SUBJECT: Transmittal of Westinghouse Proprietary and Non-Proprietary Responses to U.S. Nuclear Regulatory Commission Requests for Additional Information on the AP1000 Application for Design Certification

**“AP1000 Design Certification Review –
Response to Request for Additional Information”**

Response to Request For Additional Information

Figure 7.1-1

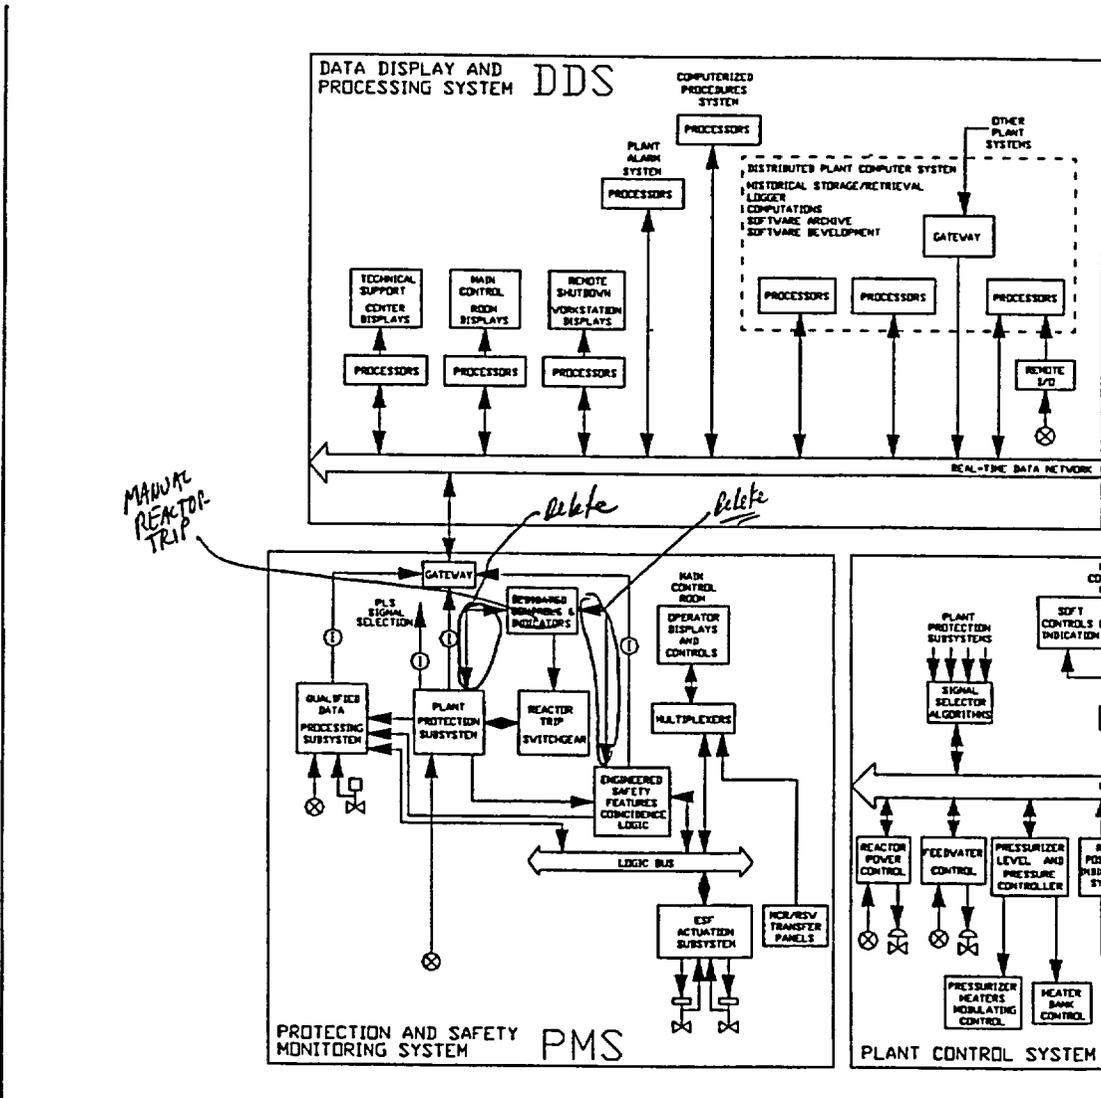
Note that there is an error in DCD Figure 7.1-1. The gateway needs to communicate to the Engineered Safety Features Coincidence Logic (as well as from the ESF Coincidence Logic) to accomplish the second function listed above. DCD Figure 7.1-2 (Revision 1) shows this link correctly.

Revise DCD Figure 7.1-1 as shown.

Revise Figures 7.1-1 and 7.1-2 as shown to reflect that the manual reactor trip switches are the only dedicated controls and indicators hardwired into the PMS.

Figure 7.1-2

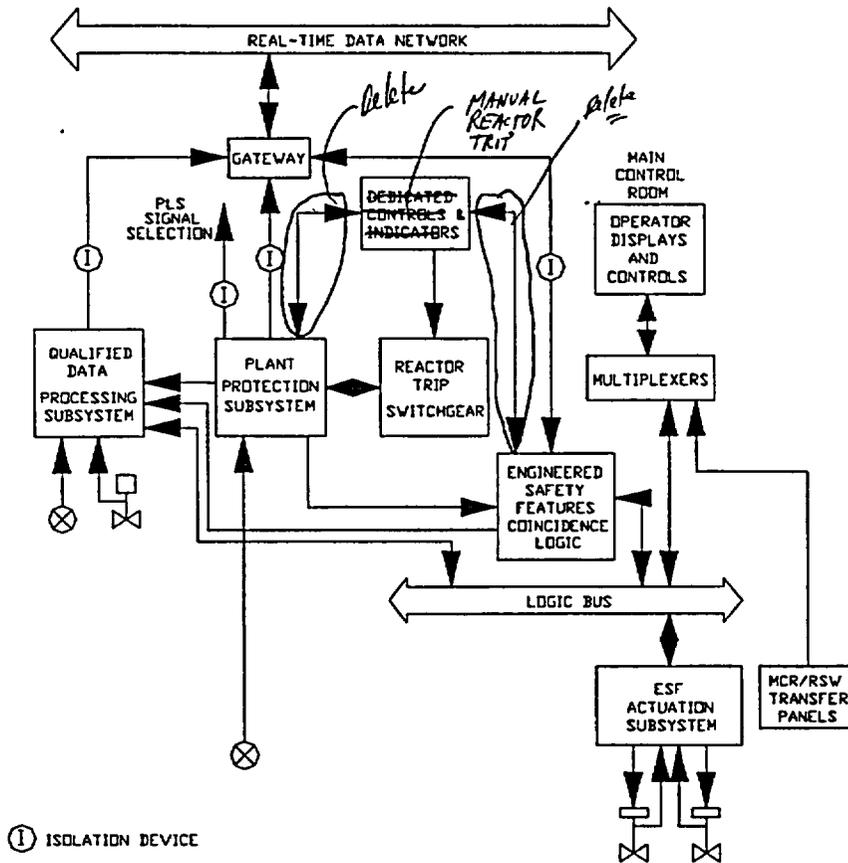
420.8 (DCD Figure 7.1-2)

Figure 1: Heat Transfer Coefficients vs. Distance Along Tube - Single Phase

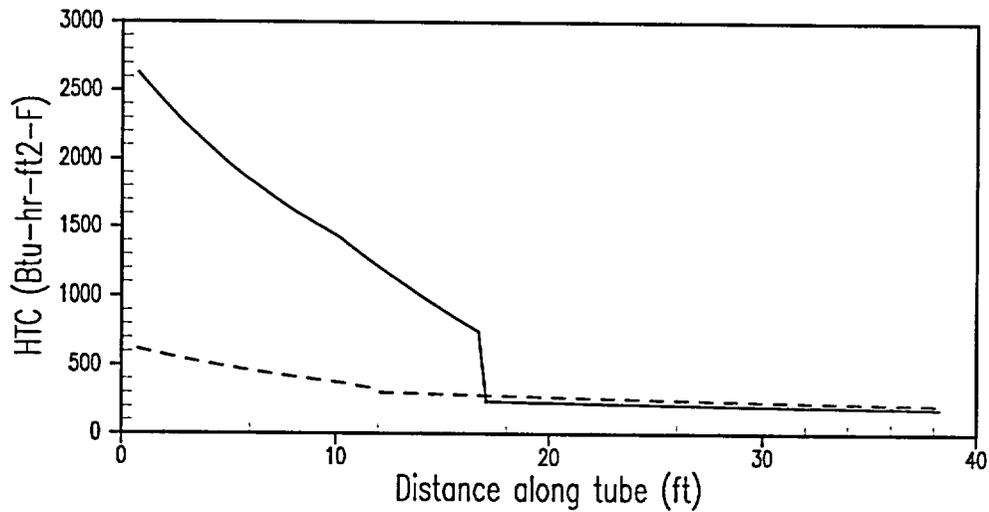
The heat transfer calculation described in the previous section was performed using both the NOTRUMP and LOFTRAN nucleate boiling correlations. In both cases, the top of the tubes experience boiling and transition to natural convection as the fluid temperature inside the tubes decreases and the pool water pressure increases along the vertical portion of the tubes. The heat transfer coefficient as a function of length along the tubes is shown in Figure 1. This figure shows that the Thom correlation predicts significantly higher film coefficients for nucleate boiling than the modified Rosenhow correlation.

Figure 2: Heat Transfer Rate vs. Distance Along Tube - Single Phase

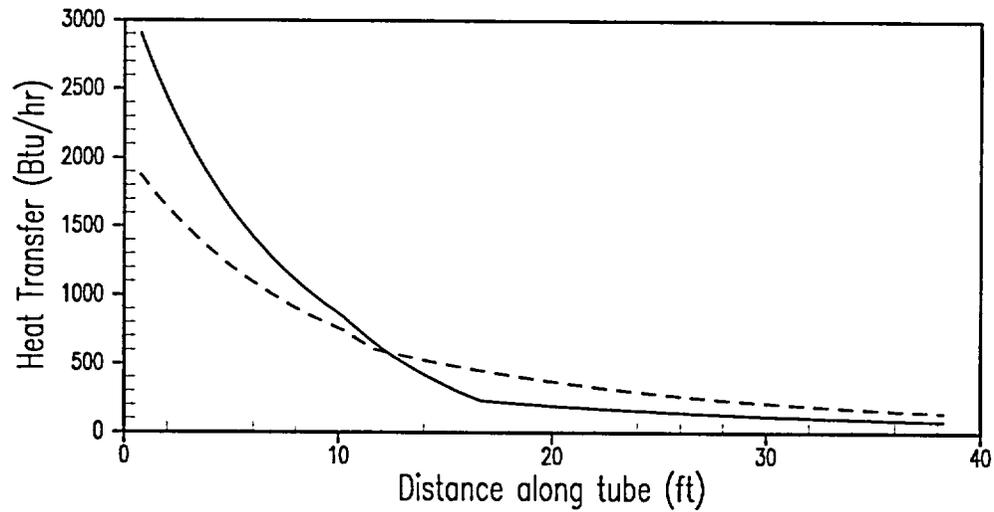
Figure 2 shows the local heat transfer rate as a function of length along the tubes. This plot shows that although the film coefficient in the boiling region is higher, the wall temperature is

Figure 3: Primary Fluid Temperature vs. Distance Along Tube – Single Phase

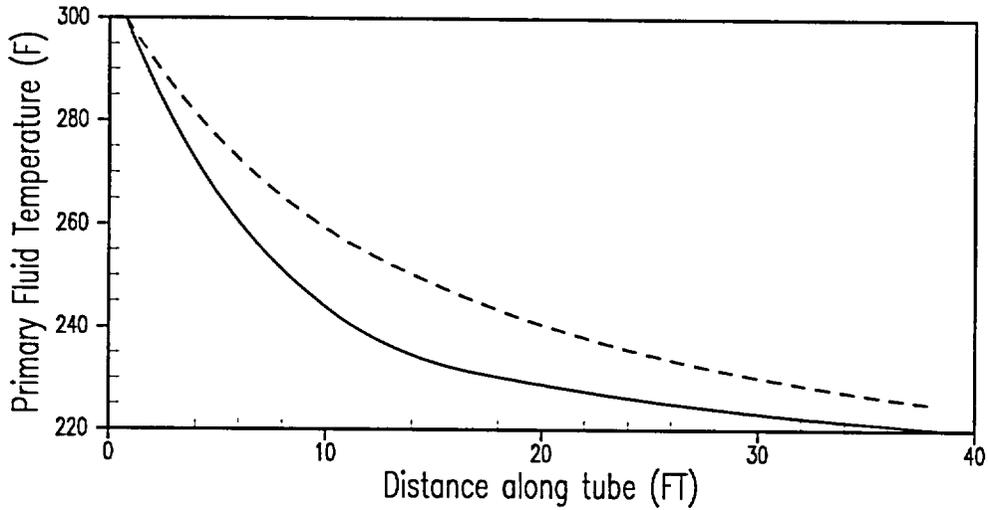
lower and the heat transfer rates are only moderately higher. In addition, the higher heat removal in the beginning of the tubes results in lower fluid temperatures inside the tubes in the lower region as is shown in Figure 3. Thus, more heat is removed in the lower region for the case where the modified Rosenhow correlation is used. The overall heat removal for the heat exchanger was 11.9 MW for the Thom case and 11.2 MW for the modified Rosenhow case. Thus, the current NOTRUMP model overpredicts the PRHR heat transfer by about 6% for these typical conditions.

Figure 4: Heat Transfer Coefficients vs. Distance Along Tube – Two Phase

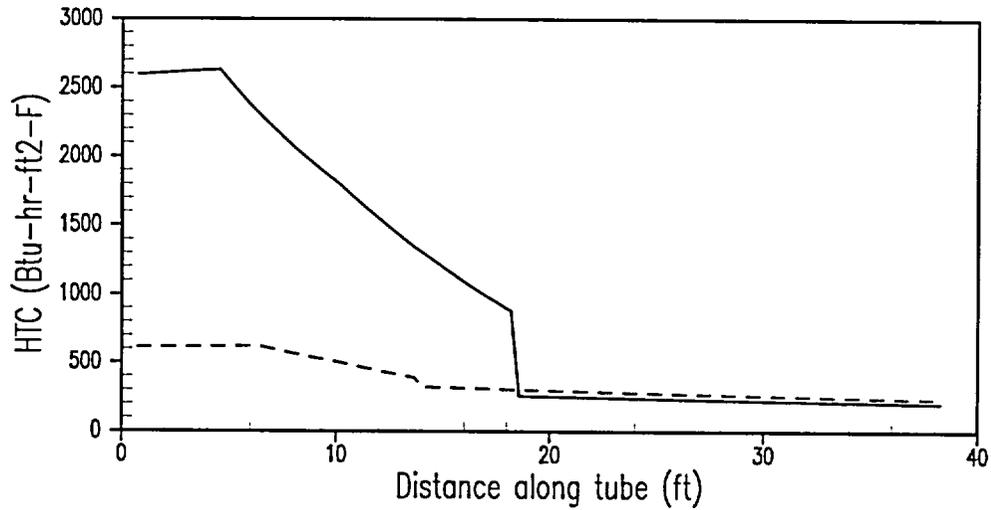
Figure 4 shows that the heat transfer coefficient is higher for a larger portion of the tube length using the Thom correlation. Figure 5 shows that there is significantly higher heat transfer rates when the tubes are condensing two-phase mixture for the case using the Thom correlation. However, the vapor is condensed within a shorter tube length for this case, and in the natural convection region the higher fluid temperature inside the tubes results in higher heat transfer for the case where the modified Rosenhow correlation is used. This result is also shown in Figure 6 where the fluid temperature remains at the inlet temperature until the vapor is condensed, then falls more rapidly using the Thom correlation.

Feedwater Malfunction Event – DCD Case – DNBR Transient

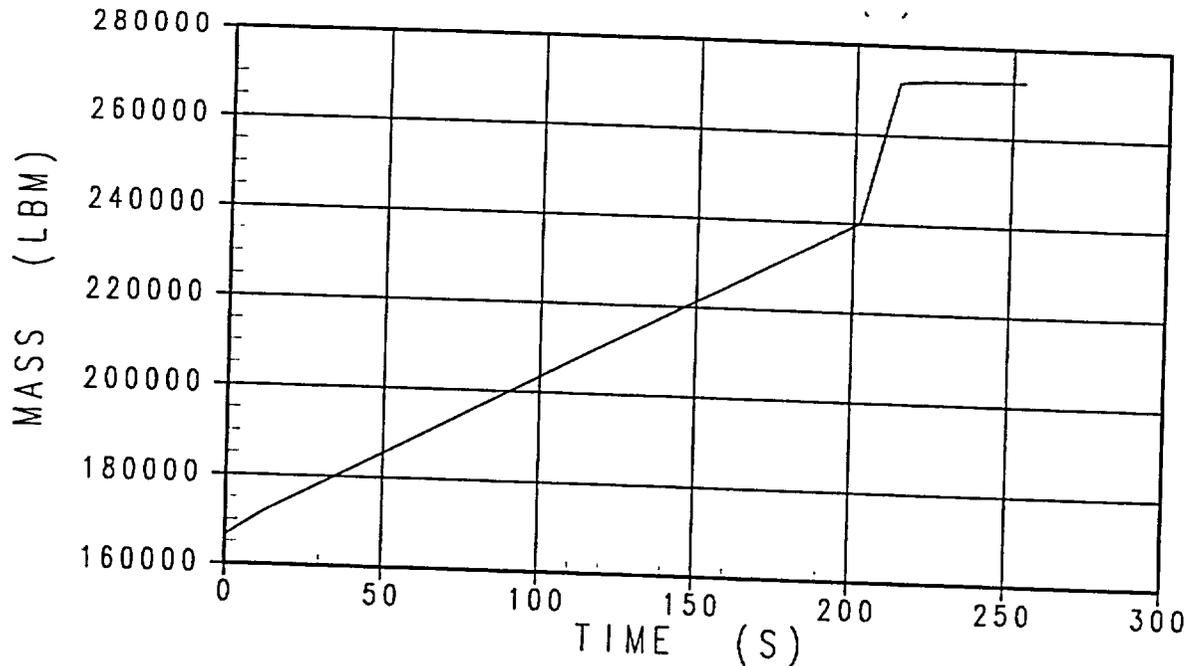
Section 15.1.2 presents the results of an analysis for the increased feedwater flow event. No figure is presented to show that the calculated DNBRs do not exceed the specific acceptable fuel design limits during the transient.

- A. Provide the DNBR figure for the staff to review.
- B. No information is presented to address the SG overfill issue. Specifically, for the case initiated from a full opening of a feedwater isolation valves without the isolation valve reclosure because of a single failure consideration, the applicant is requested to identify the safety related equipment that are credible to isolate the feedwater in order to prevent SG overfill.
- C. If non-safety related systems or components (such as the feedwater control valves or feedwater pumps) are credited to isolate or terminate the feedwater, the applicant should show that the non-safety related system or component is reliable for feedwater isolation and provide a TS LCO to meet the requirements specified in (c)2(ii)(C) of 10 CFR 50.36.
